S E R V I C E N O T E

**E4401B, E4402B, E4403B, E4404B, E4405B, E4407B, E4408B, and E4411B ESA Spectrum Analyzer family. Also E7401A, E7402A, E7403A, E7404A, and E7405A EMC Pre-Compliance Analyzers.**

**Intermittent screen "flicker" due to a cold solder joint**

DATE: January 2001

**Figure 1**

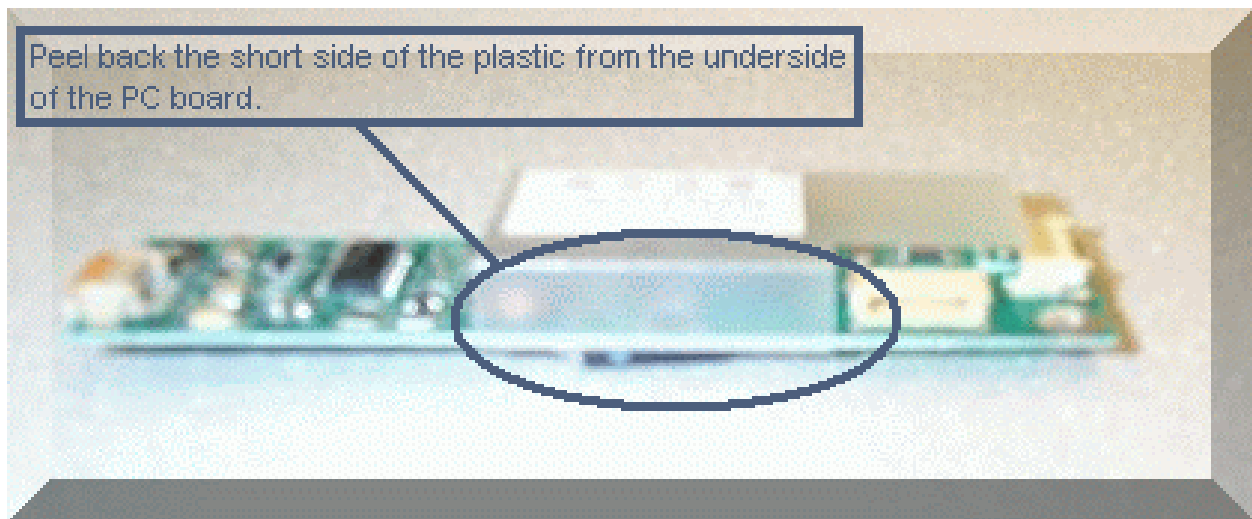
- 1) Peel back the plastic shield on the backlight inverter board. See Figure 1.

**Figure 2**

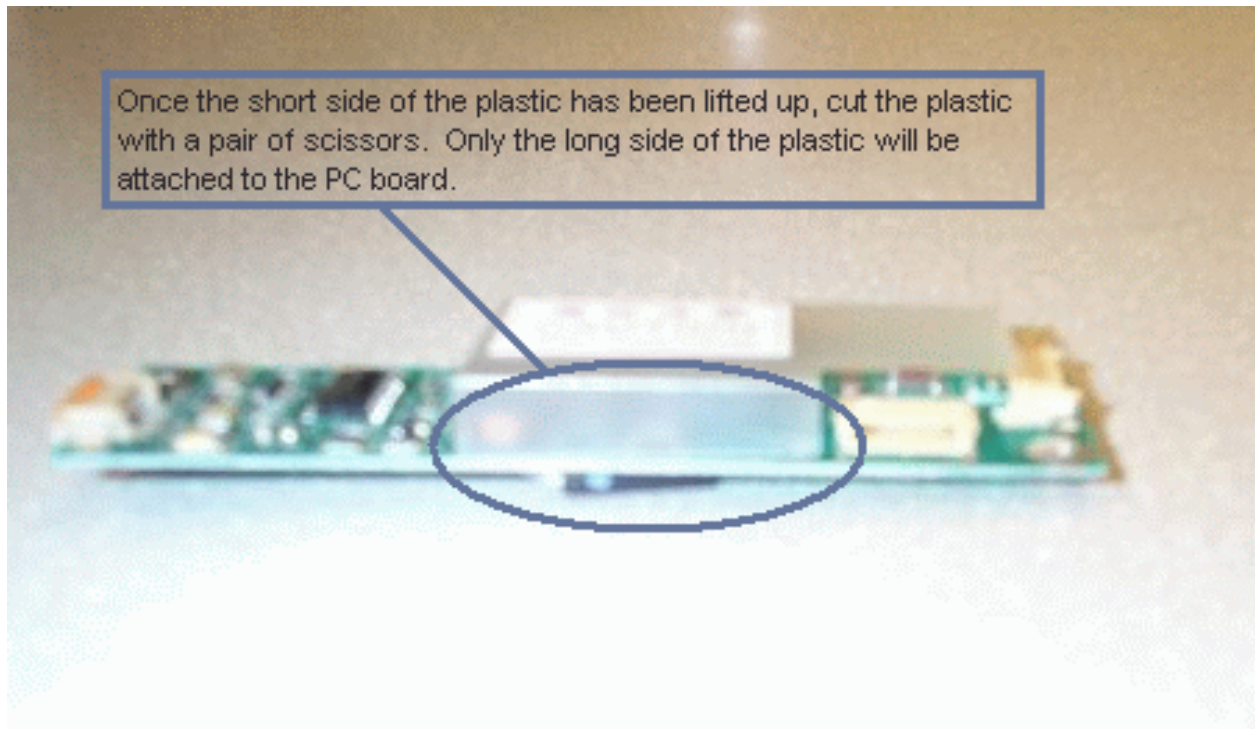
- 2) Cut the plastic with a pair of scissors. See Figure 2.

**Figure 3**

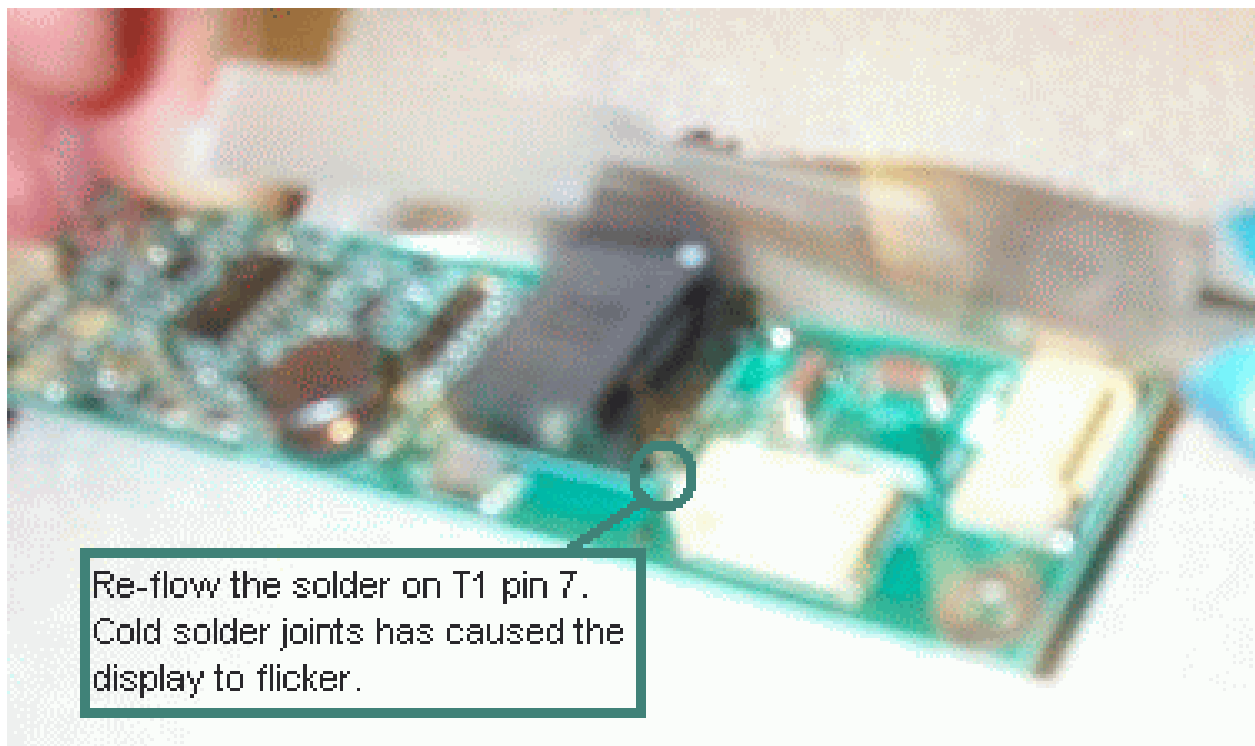
3) Re-solder pin 7 of the transformer on the backlight inverter board. See Figure 3.
